NOTICE TO PROCEED

Project: Grand Junction Fire Department Fire Station #3 Construction
IFB-4889-21-DH

Project:
Grand Junction Fire Department
Fire Station #3
GMP Estimate

A3-6

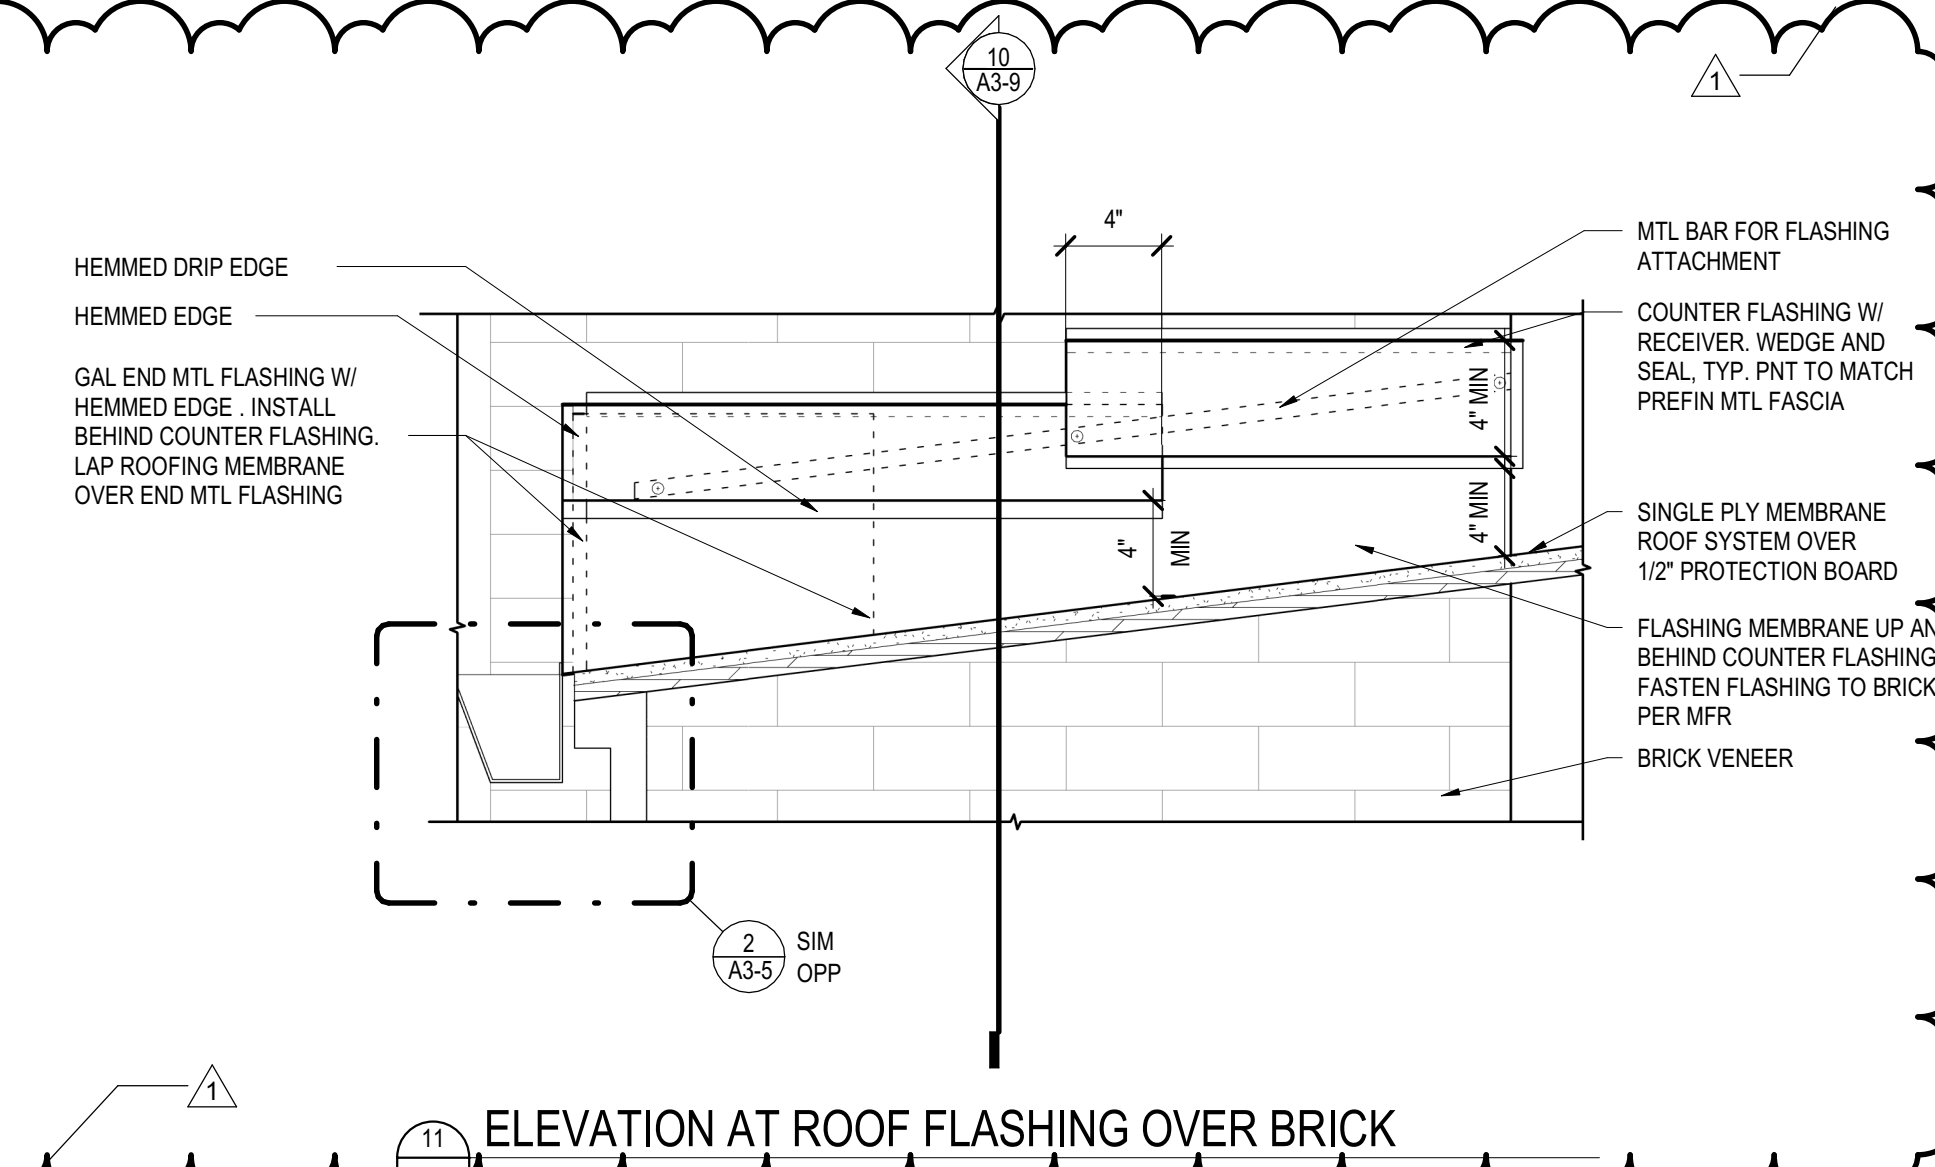
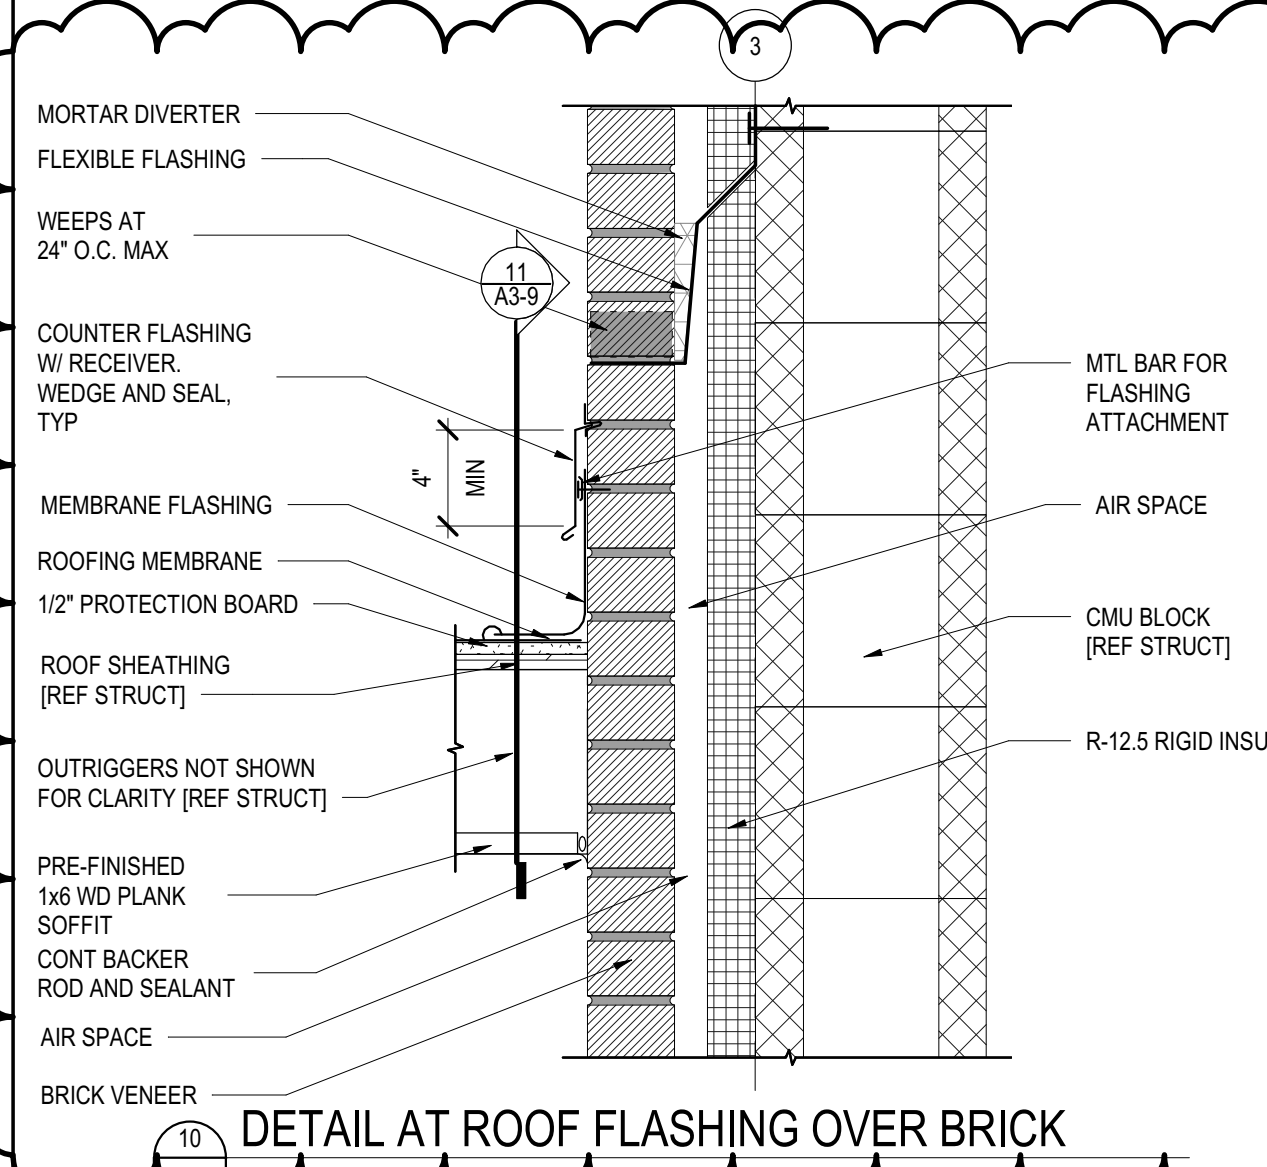
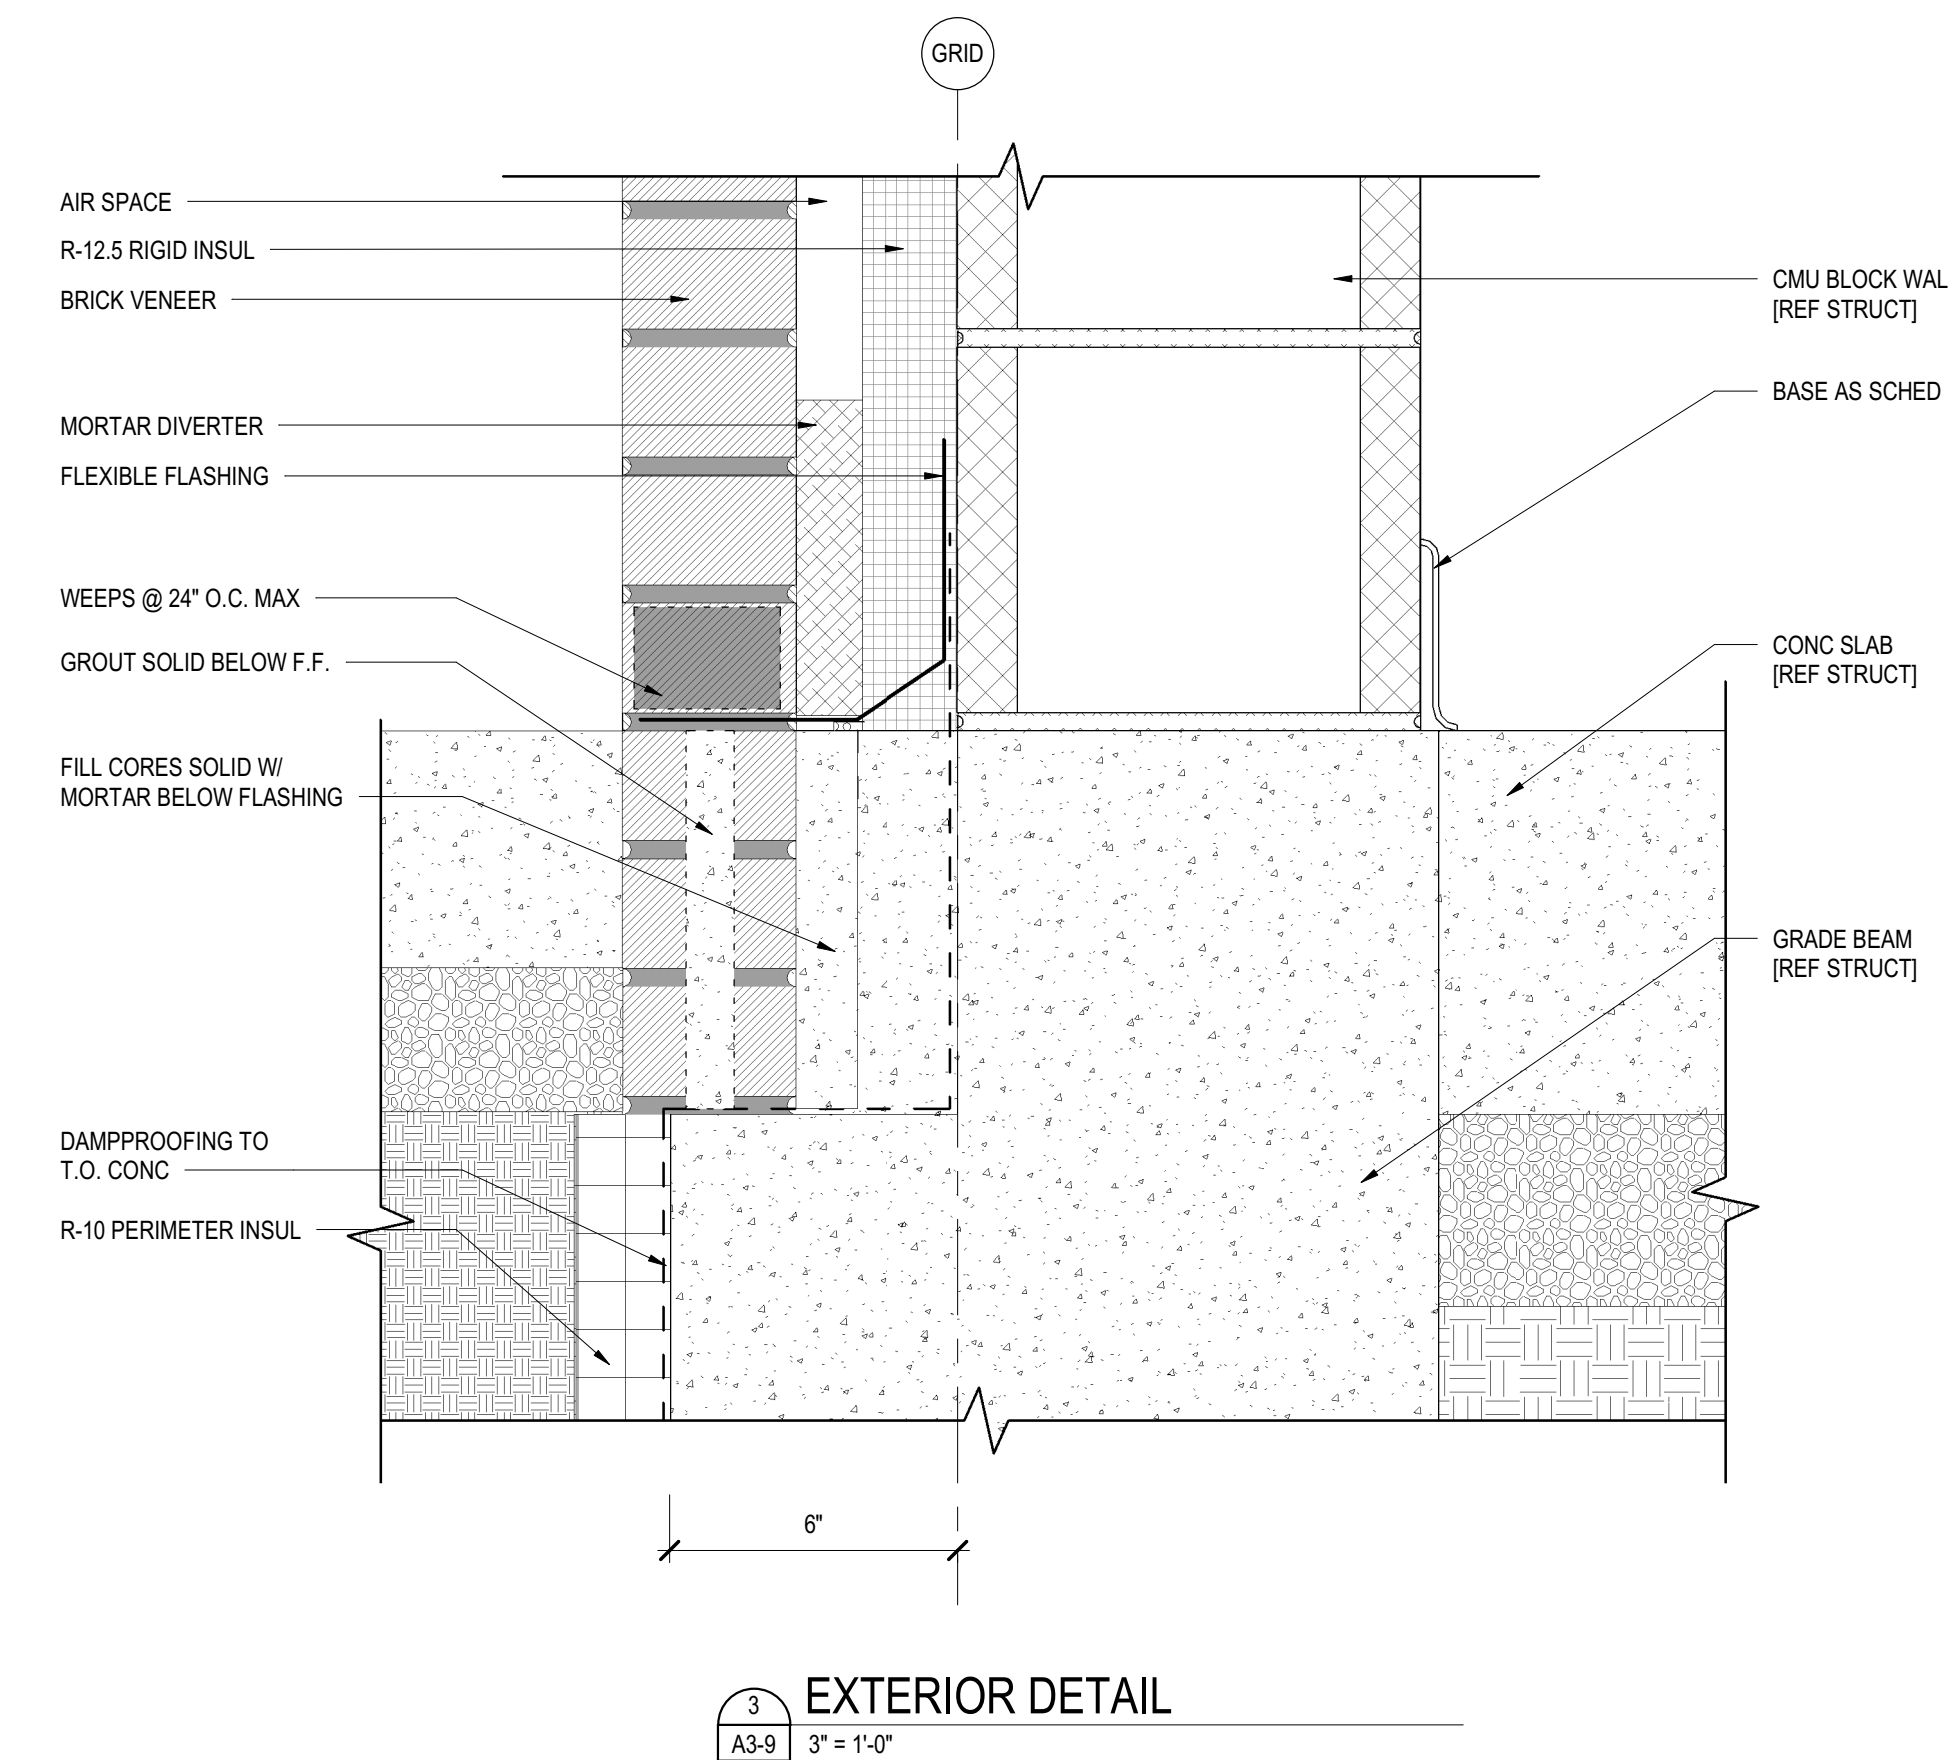
5. Please see attached revised Architectural Sheets A3-6 and A3-9:
 - Revised Detail 1/A3-6 on sheet A3-6, to include dimension string from roof surface to bottom of fiber cement siding.
